Work Order ID 85319

Item Name: Crosstube Turning Detail

DRAWING NO. D407-667-145	TITLE CROSSTUBE ASS'Y (407 HIGH FWD)	REV. C	DART AEROSPACE LTD ENGINEERING ORDER		D.E.O. NO. D407-667-145-C-1	SHEET NO. SHEET 1 OF 1	SCALE NTS
DRAWN <i>Q</i>	CHECKED <i>ASS</i>	MFG. APPR. <i>AB</i>	APPROVED <i>WD</i>		DE APPR. <i>HA</i>		
DATE 11.07.15	DATE 11.07.22	DATE 11.07.22	DATE 11/07/22		DATE 11.07.21

REPLACE MAGNOBOND WITH PROSEAL.

D407-667-145
ASSEMBLY DETAIL
(VIEW LOOKING FWD)

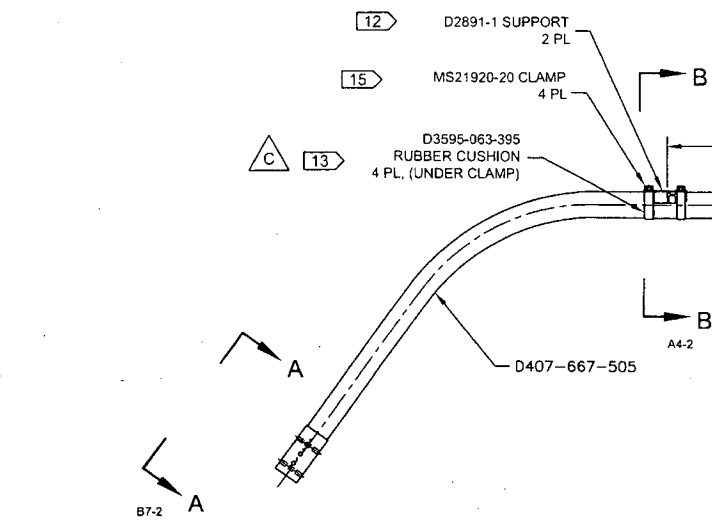
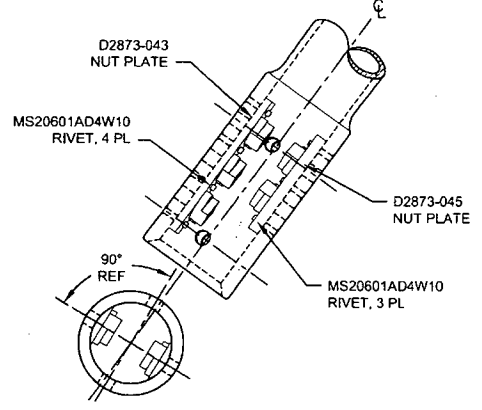
NOTE 12 & 15, SHEET 1 IS AMENDED AS FOLLOWS:

Item	Qty -145	Part Number	Description
9	A/R	PROSEAL 890 B-2	SEALANT, AMS-S-8802 CLASS B-2

- 12) TO INSTALL D2891-1 SUPPORT: ABRASE MATING SURFACE OF SUPPORT AND CROSSTUBE WITH 180-GRIT SANDPAPER AND REMOVE RESIDUE WITH MEK (OR EQUIVALENT). APPLY A 0.04" TO 0.07" THICK LAYER OF PROSEAL 890 CLASS B-2 (OR AMS-S-8802 CLASS B-2) SEALANT TO MATING SURFACE OF SUPPORT.
- 15) TORQUE CLAMPS 80 TO 100 IN-LB. ENSURE AT LEAST 1.5 THREADS SHOWING IN SAFETY AND THAT NUT HAS NOT BOTTOMED-OUT AFTER TORQUING. **PRIOR TO PACKAGING, RE-CHECK TORQUE ON CLAMPS AFTER PROSEAL 890 SEALANT HAS CURED FOR 72 HOURS.**
